780-001-11

ADDENDUM NO. 1

Freeman Public Schools
 Adams, Nebraska
 TCEP No.: 780-001-11

Addendum #01
Supplemental Drawing: SDM-008
Revision of Sheet: M4.01
Date: 09/26/12

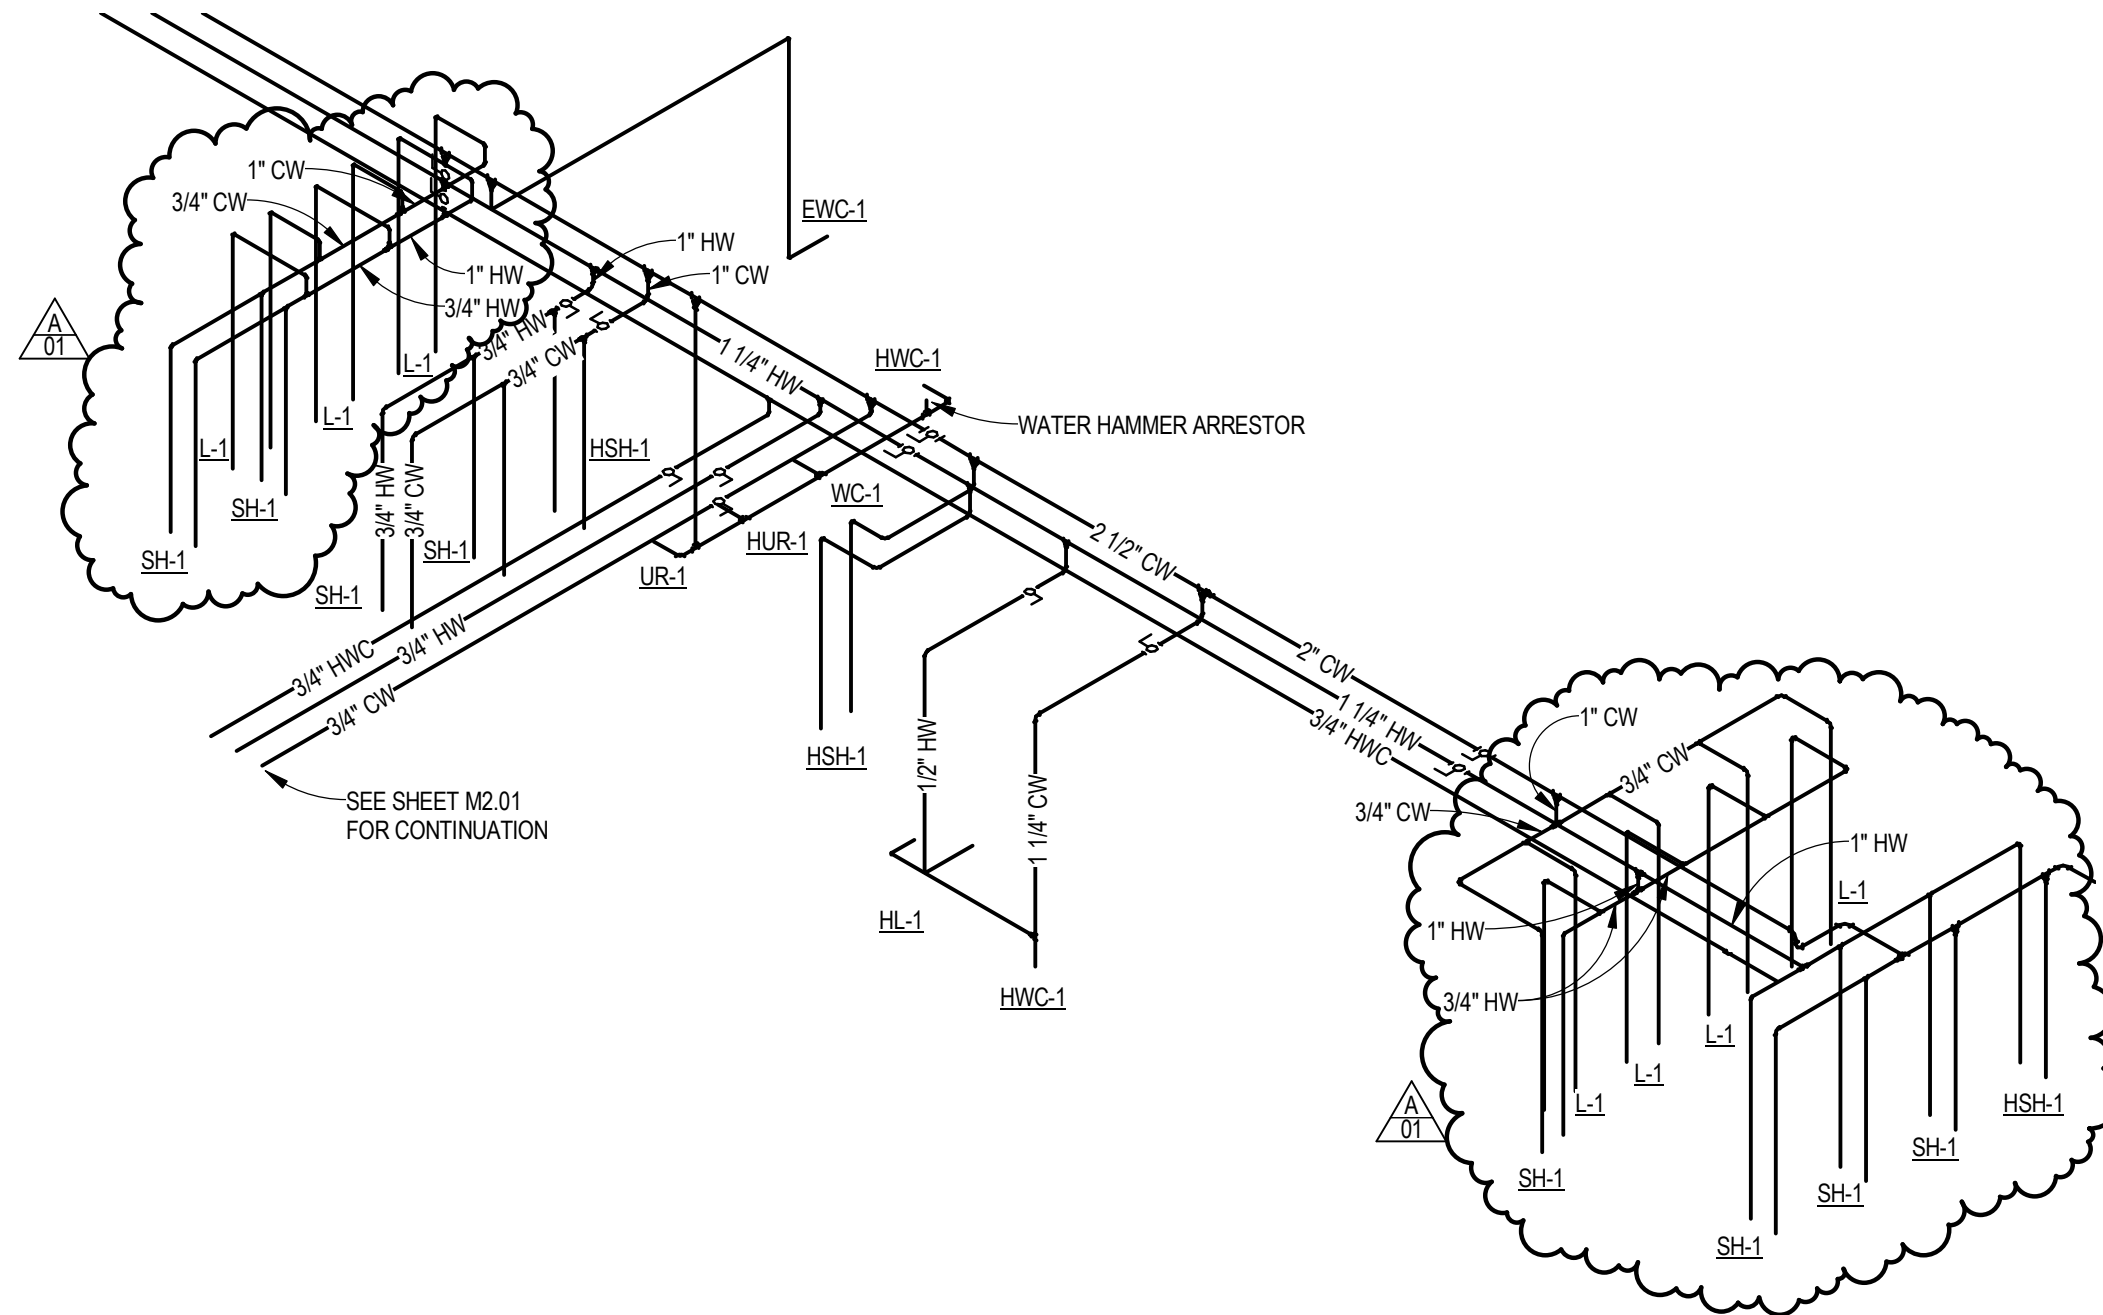
Refer to attached supplemental drawing SDM-008 for revised waste & vent piping for additional showers.

Addendum #01
Supplemental Drawing: SDM-009
Revision of Sheet: M4.02
Date: 09/26/12

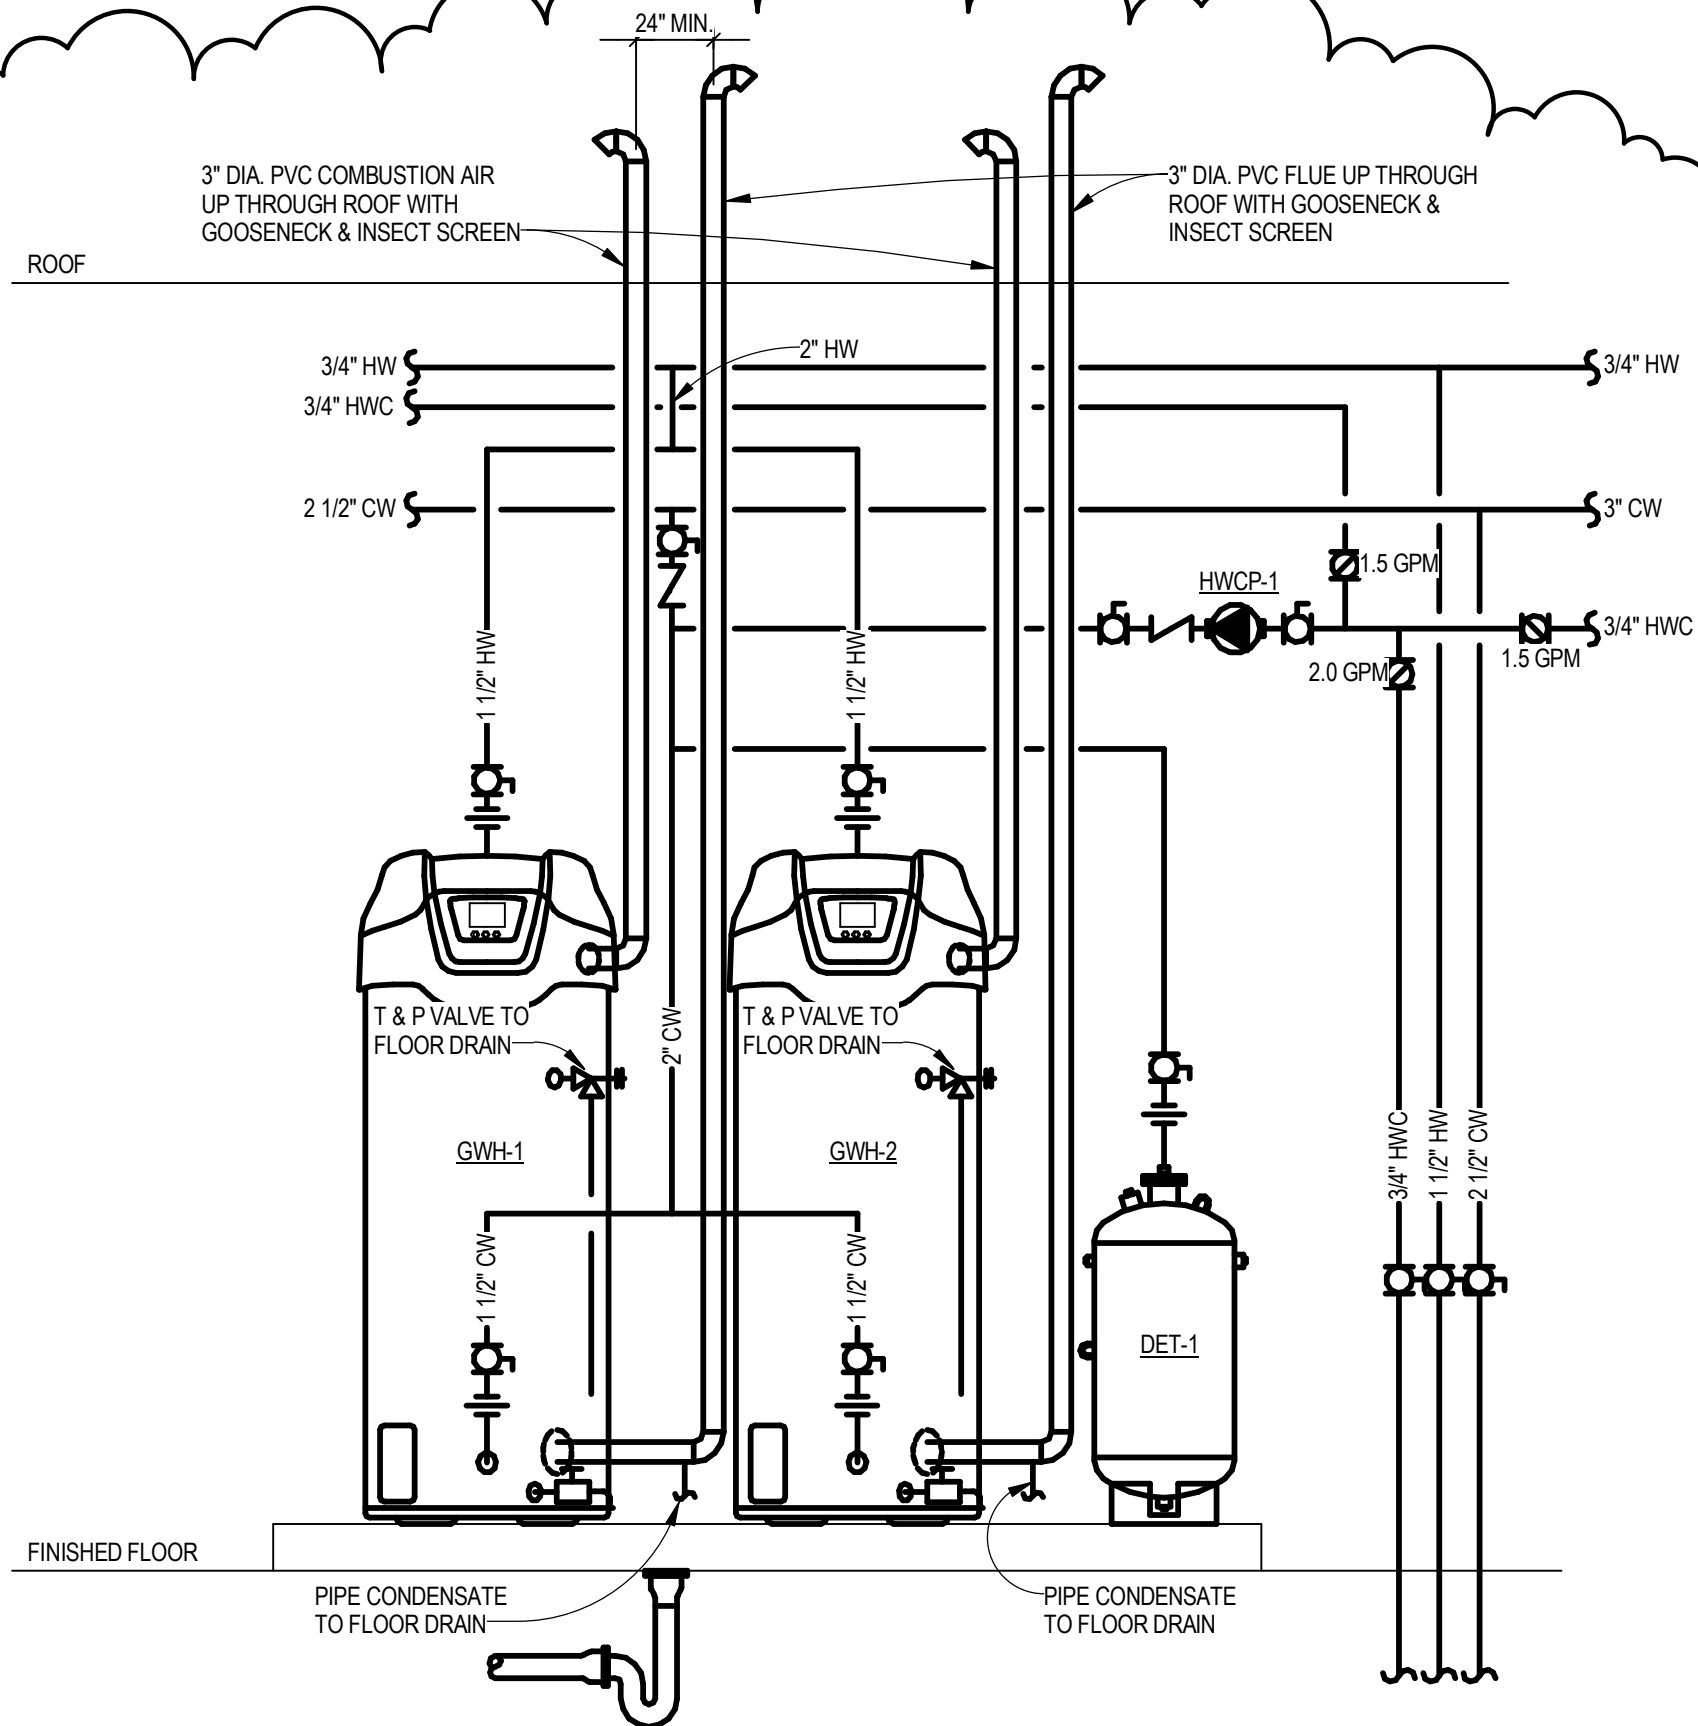
Refer to attached supplemental drawing SDM-009 for revised water piping for additional showers and water heater.

Addendum #01
 Supplemental Drawing: SDE-001
 Revision of Sheet: E1.00
 Date: 09/26/12

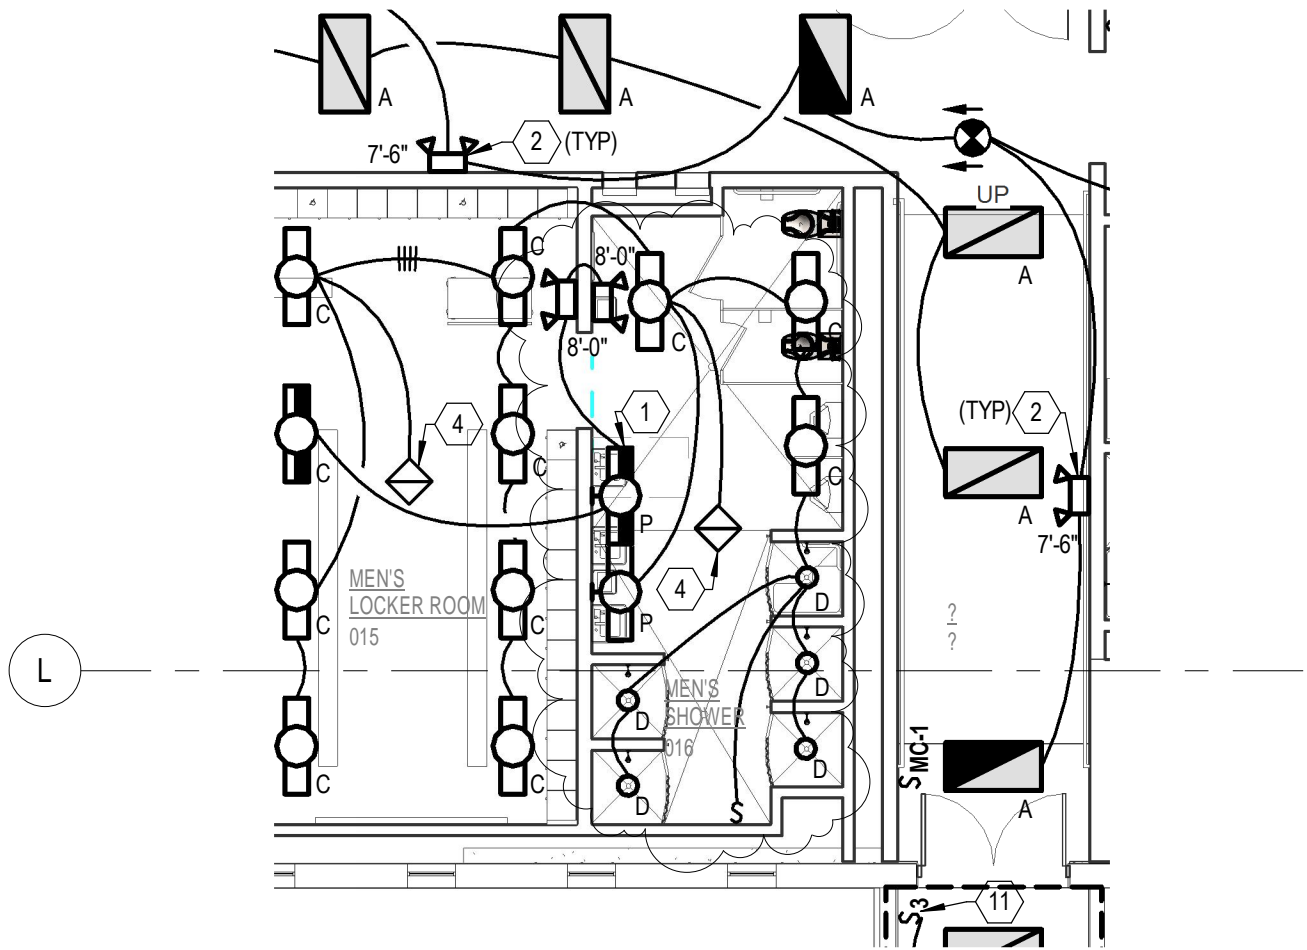
Refer to attached supplemental drawing SDE-001 for changes to lighting serving Men's Shower 016.

Addendum #01
 Supplemental Drawing: SDE-002
 Revision of Sheet: E1.01
 Date: 09/26/12

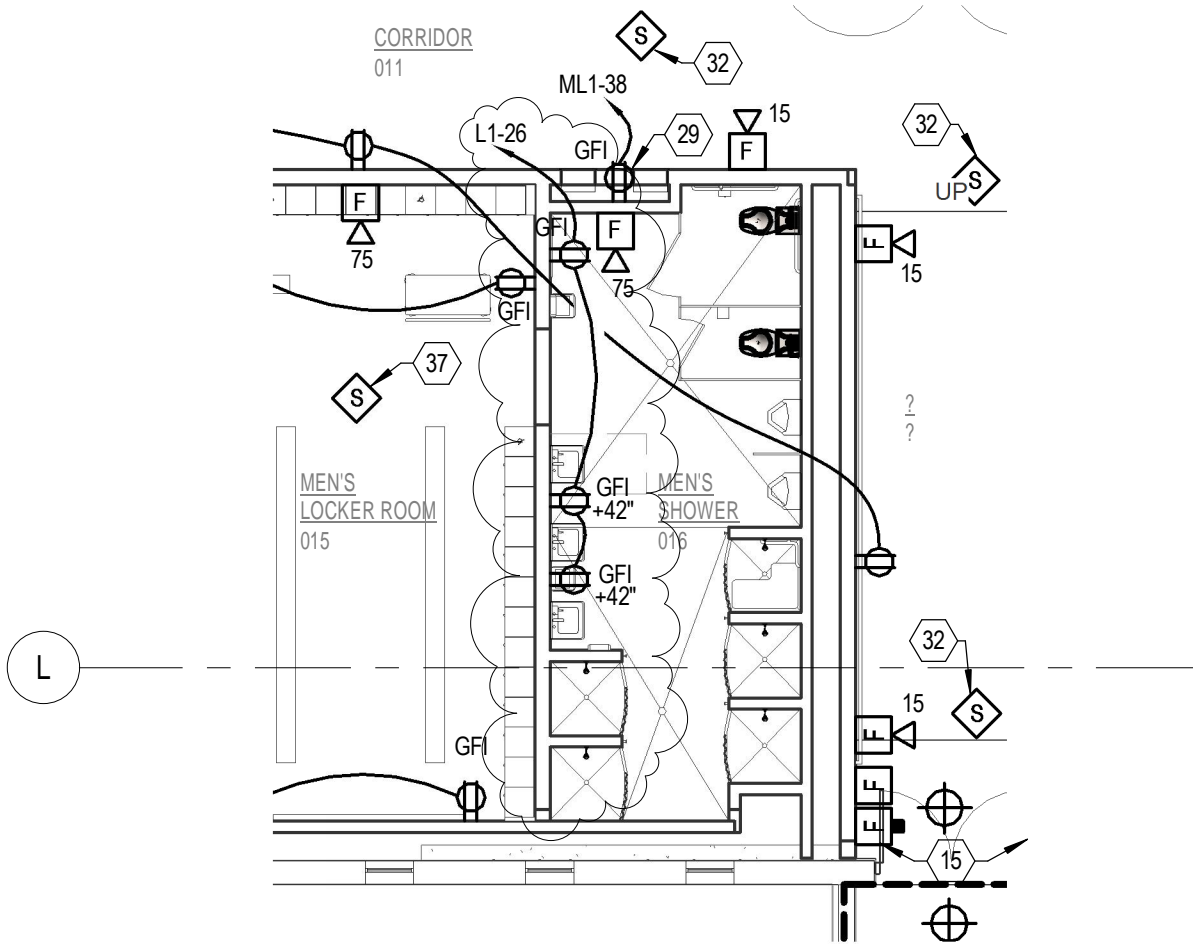
Refer to attached supplemental drawing SDE-002 for changes to lighting serving Women's Shower 022.

Addendum #01
 Supplemental Drawing: SDE-003
 Revision of Sheet: E2.00
 Date: 09/26/12

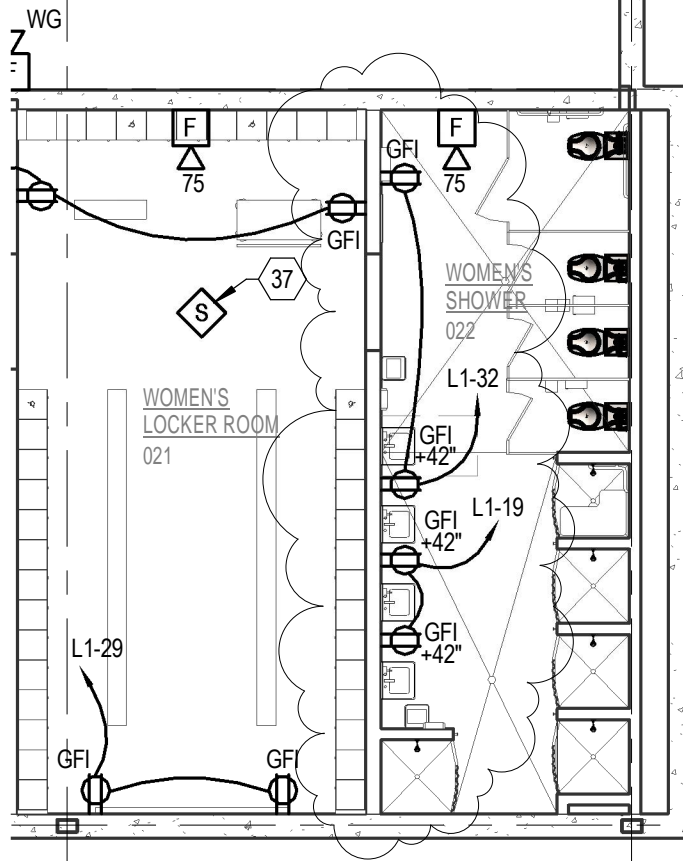
Refer to attached supplemental drawing SDE-003 for changes to receptacle power serving Men's Shower 016.
